Access Compliance Report

Public Rights-of-Way

Intersection ID: 16684	Main Street: SELWYN_FARMS_LN	Cross Street: SELWYN_OAKS_CT	Location: SW
ADA ID: D9A2E72BC12F	Ramp Type: PerpDiag	Initial Pass/Fail: Fail	Overall Compliance: No
		Severity Score: 10

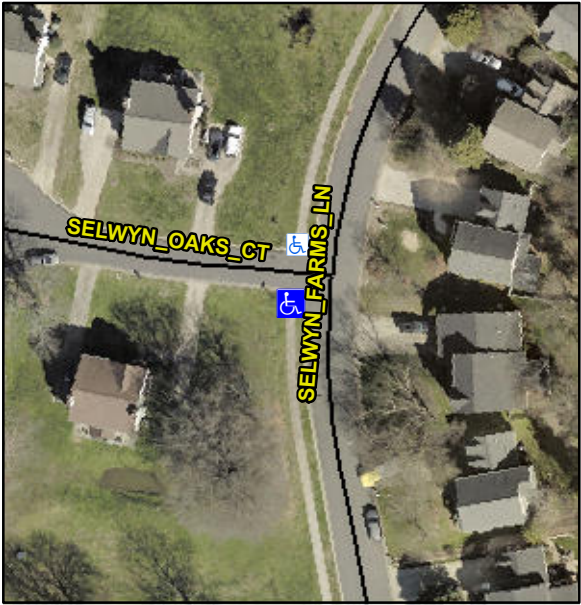
Codes/Mitigation Info/Possible Solution			Field Measurements/Component Compliance		
	Possible Solutions:		Compliance	Description	Data
	Remove & Replace Curb Ramp With Two New Directional Ramps or Equivalent.		Yes	Ramp Length (in)	37.0
			No	Ramp Width (in)	47.0
			N/A	Flare Type LT	N/A
			N/A	Flare Slope LT (%)	N/A
			N/A	Flare Traversable LT?	N/A
			N/A	Landing Length (in)	N/A
			N/A	Landing Width (in)	N/A
			N/A	Landing Slope (%)	N/A
			N/A	Landing X Slope (%)	N/A
			N/A	Landing Curb? (Y/N)	N/A
			N/A	Shared Landing?	N/A
			N/A	Gutter Ponding?	N/A
			N/A	Gutter Lip Ht (in)	N/A
			No	Painted X Walk1?	N/A
			To E	X Walk 1 Direction	N/A
			N/A	X Walk 1 Width (in)	N/A

5.8	X Walk 1 Slope (%)	N/A
			2.5	X Walk 1 X Slope (%)	N/A
			N/A	Ramp inside XWalk1?	N/A
Surveyor Notes: N/A PROW/ADA: R304.5.1, R304.5.3			N/A	Flare Type RT	N/A
			N/A	Flare Slope RT (%)	N/A
			N/A	Flare Traversable RT?	N/A
			N/A	DWS Provided?	N/A
			N/A	DWS Contrast?	N/A
			N/A	DWS Length (in)	N/A
			N/A	DWS Full Width?	N/A
			N/A	DWS Offset (in)	N/A
			N/A	Gutter Slope (%)	N/A
			N/A	Gutter X Slope (%)	N/A
			No	Painted X Walk2?	N/A
			To N	X Walk 2 Direction	N/A
			N/A	X Walk 2 Width (in)	N/A

2.6	X Walk 2 Slope (%)	N/A
			2.9	X Walk 2 X Slope (%)	N/A
			N/A	Ramp inside XWalk2?	N/A
			N/A	Clear Space?	N/A
			N/A	Clear Space to XWalk (in)	N/A
			N/A	Storm Grate/Utility Hazard?	N/A
			N/A	Storm Grate/Utility Type	N/A
			N/A	Surface Condition? (G/P)	Good
Total Cost:		\$ 3200.00
